21 Honeysuckle Drive - Newcastle

State Significant
Development
Modification Assessment
(SSD 8019 MOD 1)

August 2019

Figure 5 | Proposed Site Plan (Source: DA-0103 Rev 17 dated 15.05.19)

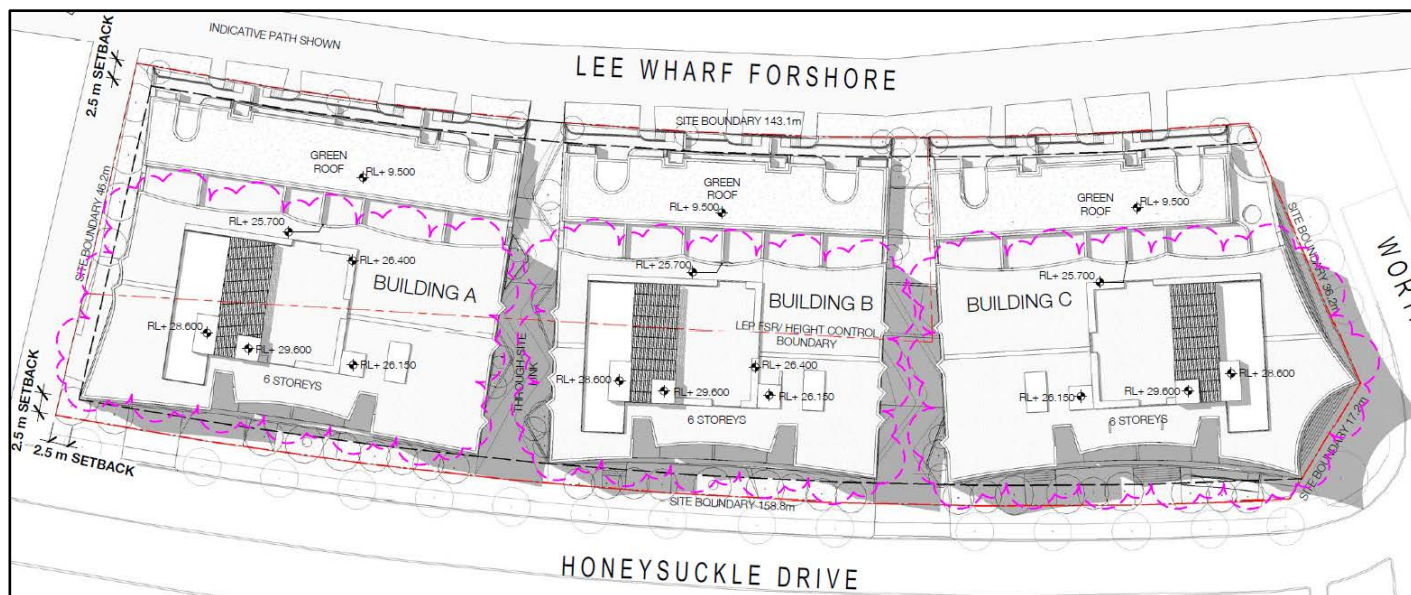
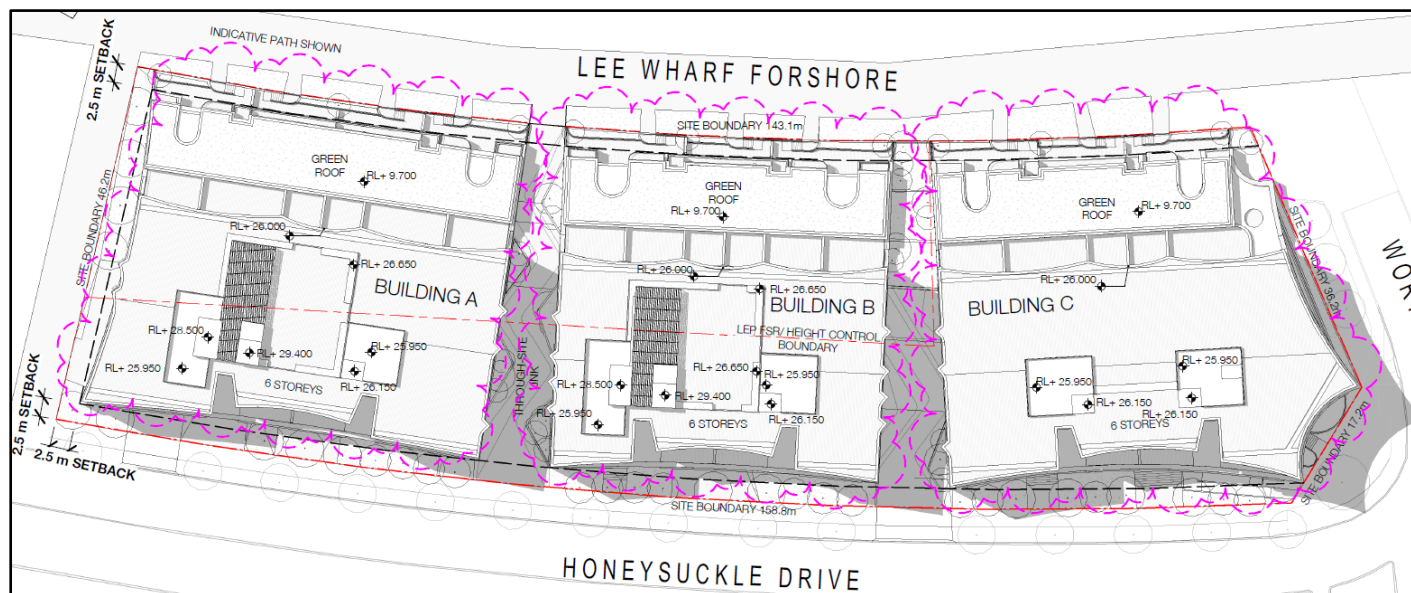
- reconfiguration and amalgamation of 12 apartments into 6 apartments and a reduction in the of the number of adaptable apartments from 16 to 15.
- removal of 30 AC condenser rooms to provide additional internal storage for 1-bedroom apartments, resulting in a 176m² increase in Gross Floor Area (GFA)
- amendments to the roof structure relating to the height of the parapets, plant items and lift overruns, including the following changes:
 - height of rooftop plant increase by 1050mm
 - parapet increase by 300mm
 - plant increase in height by 250mm
 - lift overrun decrease in height by 200mm

- o level 2 terrace roof increase by 200m
- amendment to Conditions B23 and B24 relating to the Probable Maximum Flood (PMF) design level from RL 3.65m to RL 3.4m.
- deletion of Condition F5 relating to anti-graffiti paint.

Figure 9 | Proposed Northern Elevation Plan (Source: DA-0501 Revision 17 dated 15.05.19)

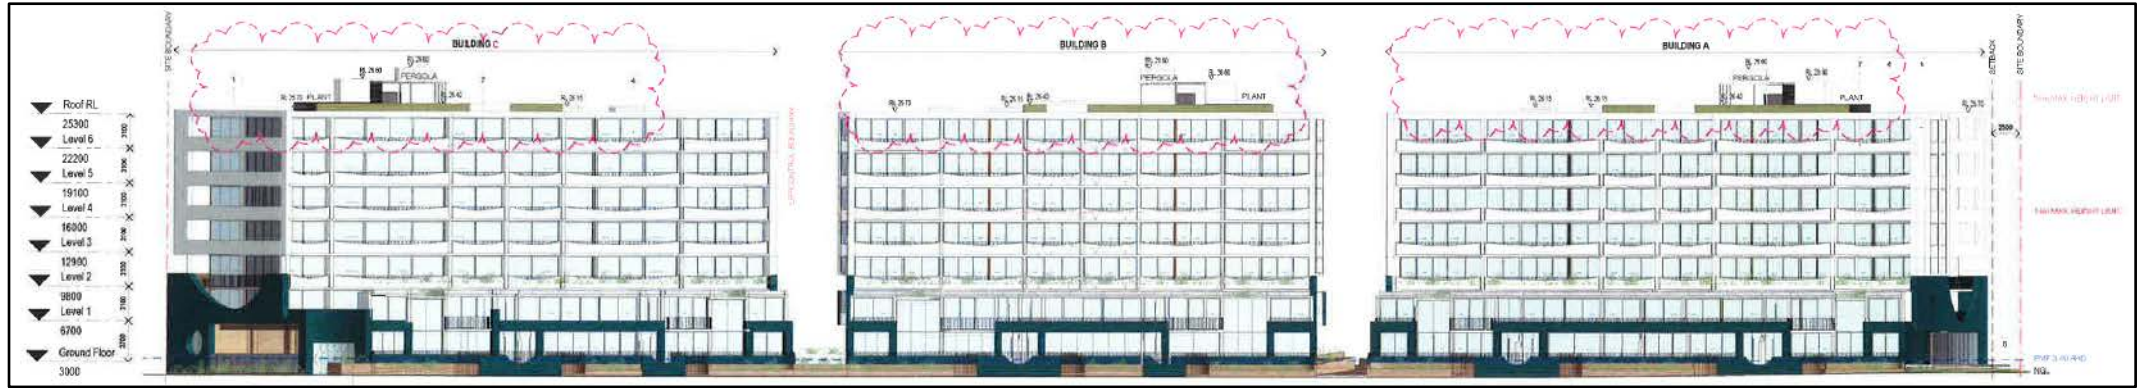
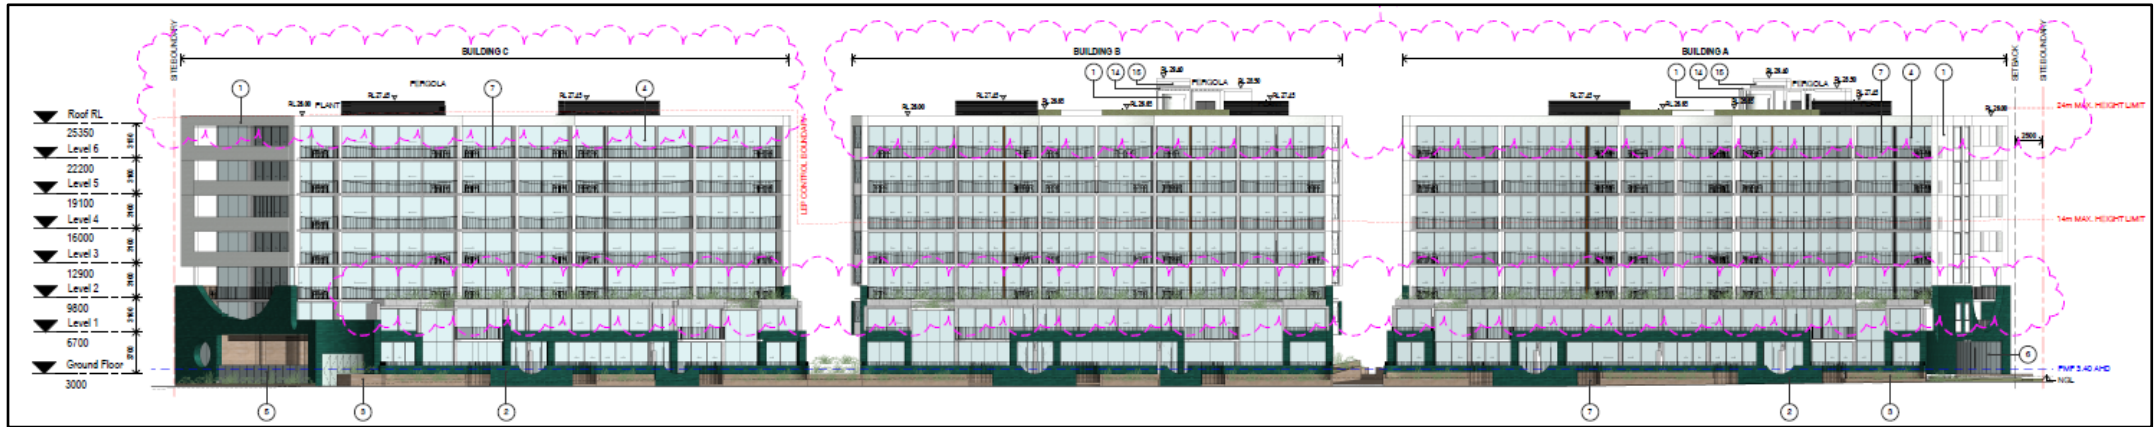
The proposal seeks to modify the building heights, resulting from amendments to the rooftop plant, parapet, and lift overruns. This increases the height of some sections of the building and reduces others (see **Table 2**).

- the height of the communal open space pergolas on Buildings A and B would increase by a maximum of 0.12m above the previously approved 26.11m height. This would result in a minor further non-compliance with the 14m NLEP height control, however the Department considers the additional exceedance to be acceptable as it is minimal and there are no discernable visual or amenity impacts.
- the new rooftop plant boxes on Building C would exceed the 24m NLEP height control by 1.13m (4.7%), are setback from the façade of the building and also have a negligible visual impact. See **Figure 12**.

Figure 10 | Approved (right) and proposed (left) ground floor commercial tenancy layout (Source: SSD 8019 Approved Plans and SSD 8019 MOD 1 Plans)

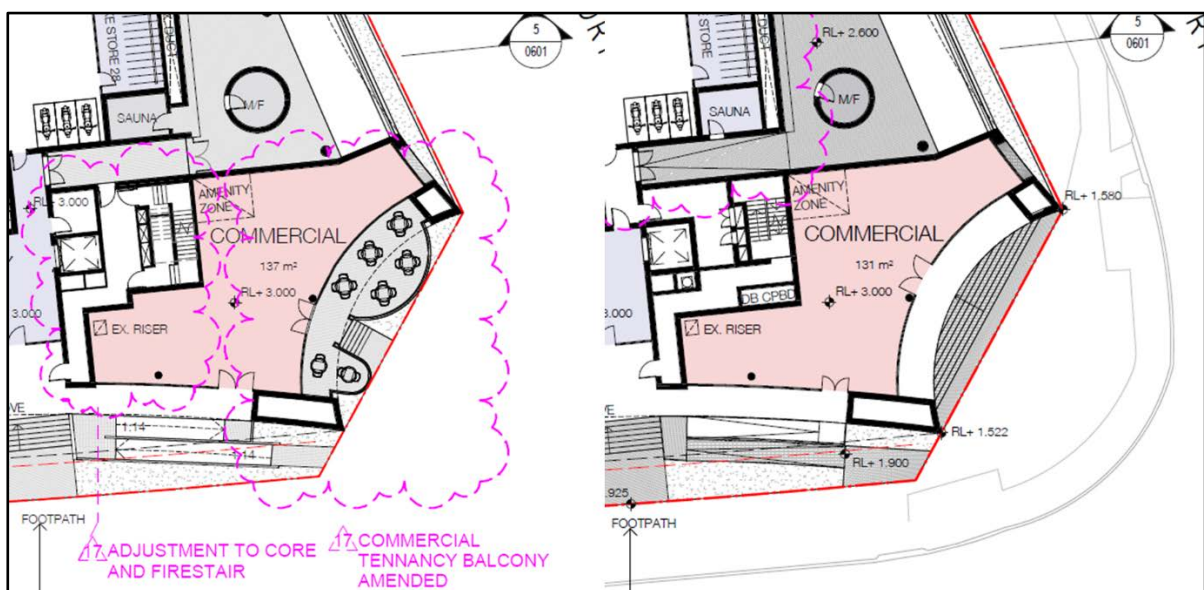
- extension of the commercial tenancy balcony on the corner of Worth Place and Honeysuckle Drive to create outdoor seating (**Figure 10**)
- minor façade amendments including the addition of bay windows on Building A
- the floor area of the 11 approved additional carparking spaces included as GFA
- details about parking, solar compliance, adaptable apartments and GFA calculations were added to the plans.

On 22 July 2019, the Applicant provided additional information to revise the proposed external brick work from white brick to terracotta finish material and confirmed the proposed ground floor tenancy balcony is open and would not create any additional GFA.

balcony	<p>Honeysuckle Drive to provide 42m² of outdoor seating.</p> <ul style="list-style-type: none"> • The Applicant advised the outdoor balcony seating would not be enclosed and would not therefore create any additional GFA. • The Department considers the proposed outdoor seating area to be acceptable as: <ul style="list-style-type: none"> o access would continue to be provided by the front stairs and side ramp o outdoor seating is not expected to have any amenity impacts, with nearby ground floor developments also being used for retail/commercial uses o outdoor seating would activate the corner street frontage management issues associated with noise and hours of operation would be dealt with under a separate DA for the fit out and use. 	<p>amendments necessary.</p> <ul style="list-style-type: none"> • Existing Condition A3 provides that separate DAs must be lodged, and consent obtained for retail, commercial and café works and uses.

Figure 12 | Proposed (top) and approved (bottom) Building C elevations (Source: SSD 8019 Approved Plans and SSD 8019 MOD 1 Plans)

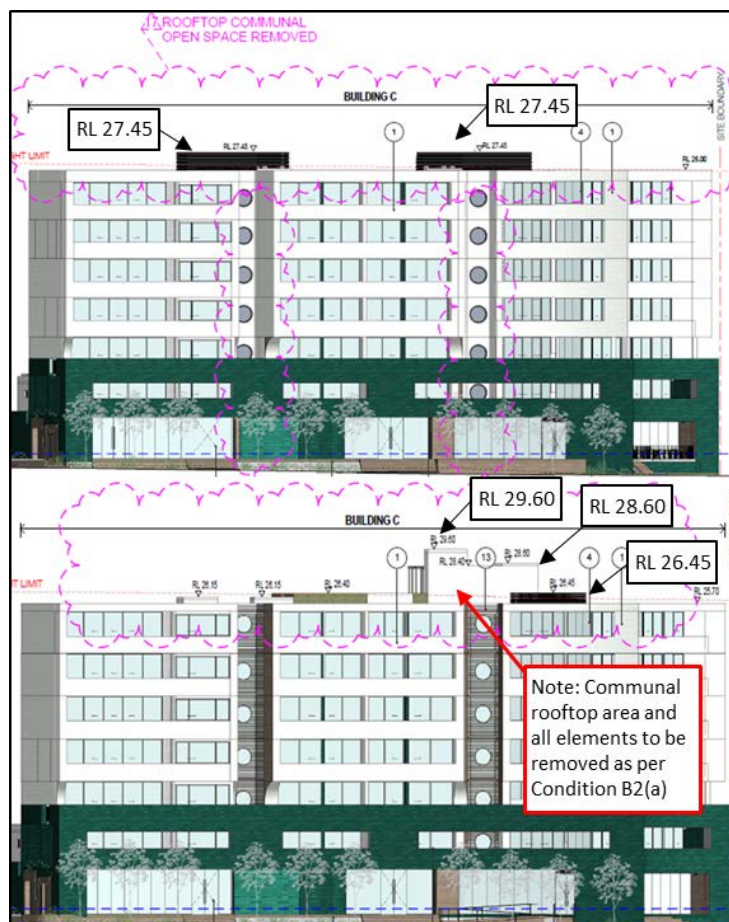
The SSD approval included a condition requiring the communal rooftop area and associated structures on top of Building C to be removed due to view loss impacts. While the communal rooftop area and majority of roof top structures would still be removed, the height of the rooftop plant would increase. As such the Department requested the Applicant provide further justification to demonstrate the suitability of locating plant on Building C.

The Department has carefully considered the clause 4.6 request and the merits of the proposal and finds the proposal to be acceptable as:

- the increase in height is minor and the plant is located in the centre of the rooftop and well setback from the site boundaries. As such, it would not have an adverse visual impact when viewed from the street or any neighbouring properties
- it would not generate any unacceptable amenity impacts with respect to view loss (discussed further in **Section 5.3**) or noise (see **Section 5.4**), to nearby landowners
- the variation would not result in a development that would be out of character with the existing streetscape.

Figure 14 | Aerial photograph showing the viewpoints (Source: Built Form Analysis by SJB Architects)

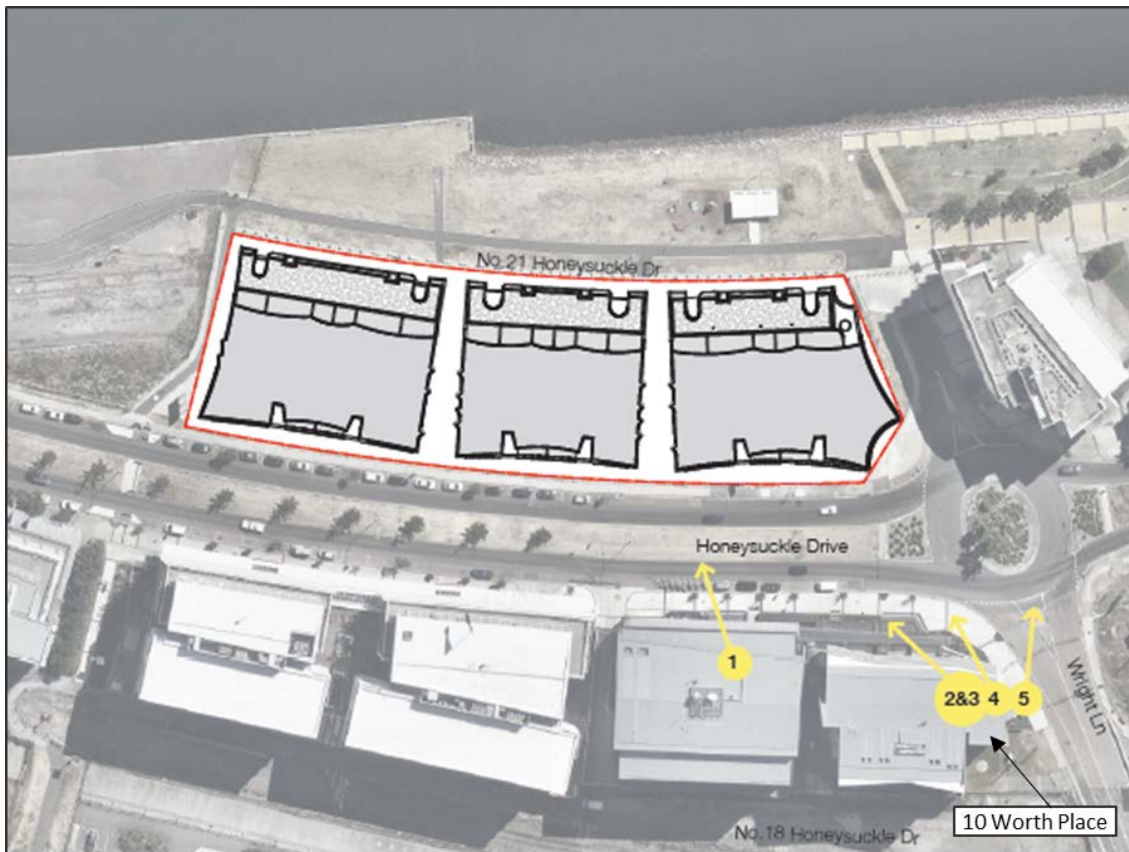
The view assessment demonstrates that from levels 7 and below, the impacts of the modification would not be significant. At locations 2 and 4 on level 9, the overall appearance of the site remains similar. There is a marginal loss of strips of water views as a result of the plant on Building C. Views of the district, horizon and areas of water towards the Hunter River are retained.

1. The affected views: The affected view is not an iconic view. While it includes narrow tracts of water views of the Hunter River/Throsby Creek above Building C (as shown in **Figure 15**) the overall view is dominated by sky views and the approved development in the mid and foreground.

2. From where the views are obtained: The views are obtained from level 9 apartments in the north and north/east windows at 10 Worth Place.
 3. The proposal would result in the following:

- two tracts of Throsby Creek/Hunter River water view in the background of Building C would be lost.
 - a small portion of district land views to the west would be lost.

- foreground building form views, horizon and overall sky views would not be affected.
- The Department considers the overall change in views compared to the original approval is minor.

Based on the above assessment, and a detailed consideration of view impacts from the most affected floors at 10 Worth Place, the Department is satisfied that the view loss impacts are reasonable. In this regard, the overall view loss impacts are considered negligible compared to the approved development.
